Our ref: 331201231L002

**Re: Vaynor Quarry Transfer Licence Variation**

Figure 2 Area A and Area B overlain on the Overall Mining Site at Vaynor Quarry (original drawing by Tir Collective for ROMP application)

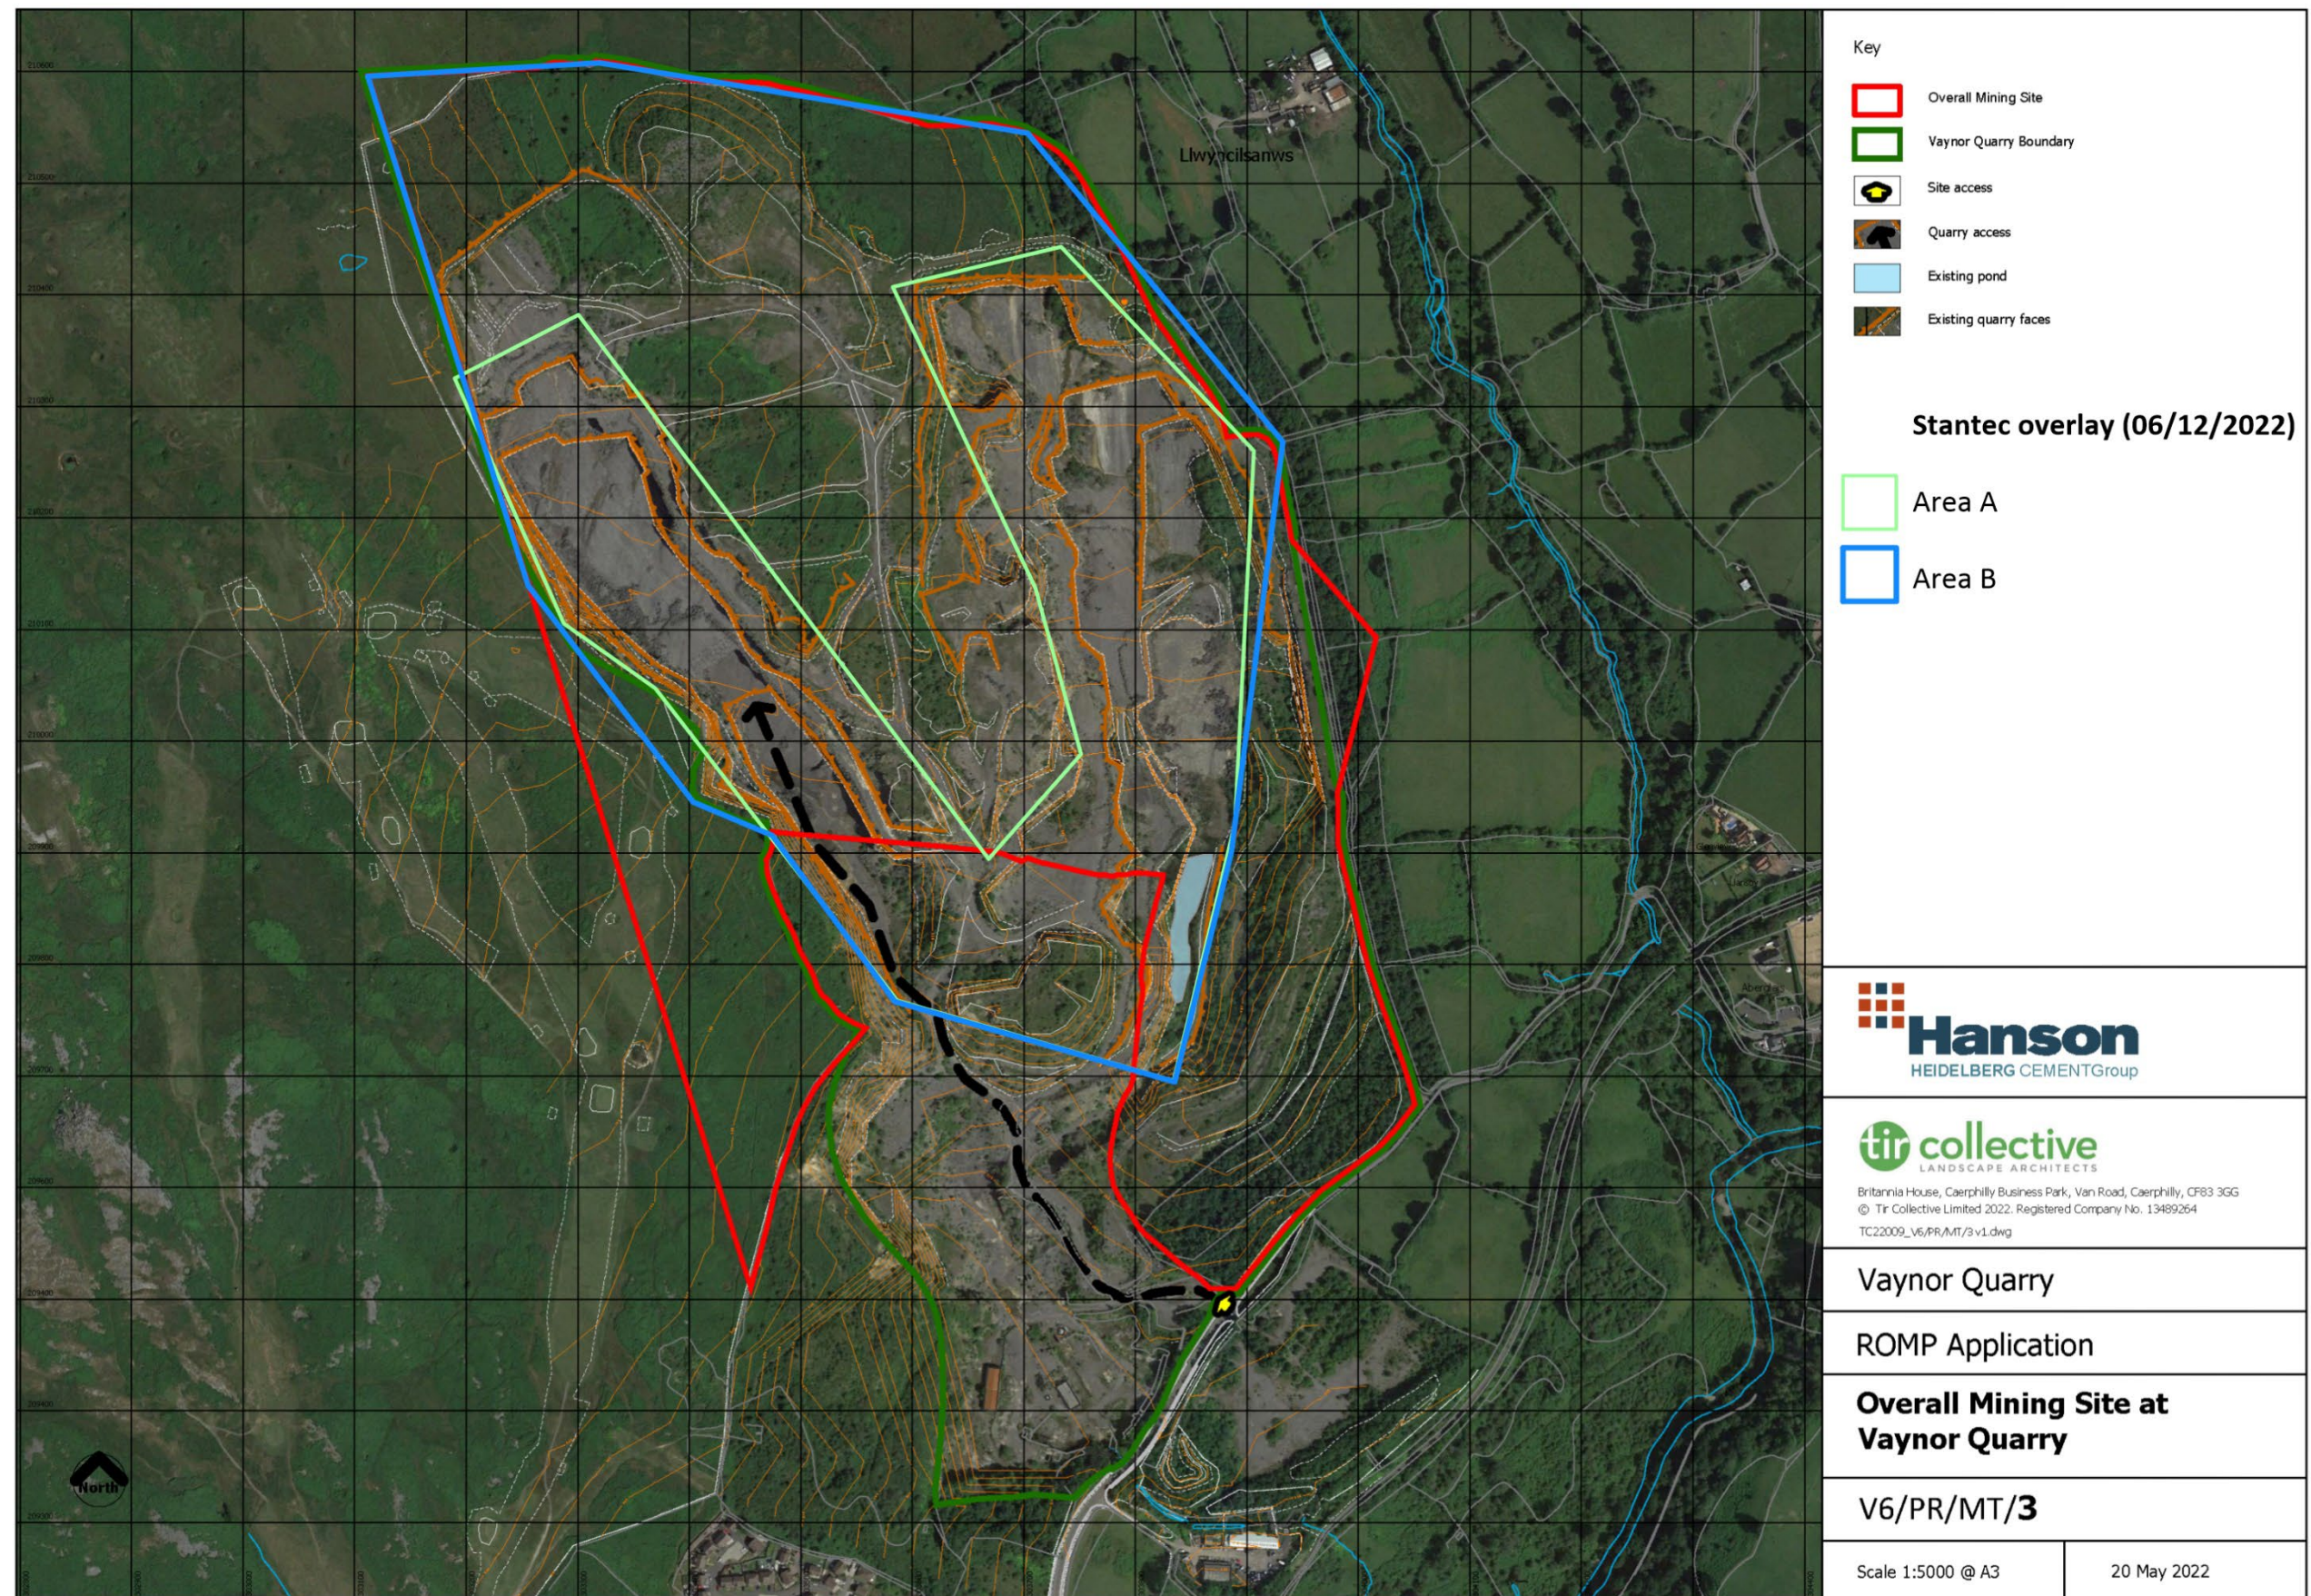
We request that a varied licence allows passive dewatering within the full area of proposed mineral extraction. We have named this larger area "Area B", with Area A being the currently licenced area. Area A and B are shown on Figure 2, and Area B is also shown on Figure 3 overlain on the final development plan. Area B includes all of Area A plus all of the proposed mineral extraction area.

The means of abstraction and infiltration will remain the same as in the existing permit. The flow rate of water from the quarry faces is likely to increase as the quarry is expanded, and the infiltration rate will increase in response to the additional water. As the rate of seepages from the quarry faces is both uncontrollable and unmeasurable, we presume that the limit on the licence, if granted, will

continue to be by a spatial restriction but covering the full proposed mineral extraction area (i.e. Area B).

*2.1 Within the area marked Area B on the map and not outside the boundary formed by straight lines running between the following 10 National Grid References: SO 03112 10596, SO 03320 10608, SO 03704 10545, SO 03933 10268, SO 03887 09901, SO 03836 09694, SO 03585 09766, SO 03475 09915, SO 03404 09945 and SO 03256 10139.*
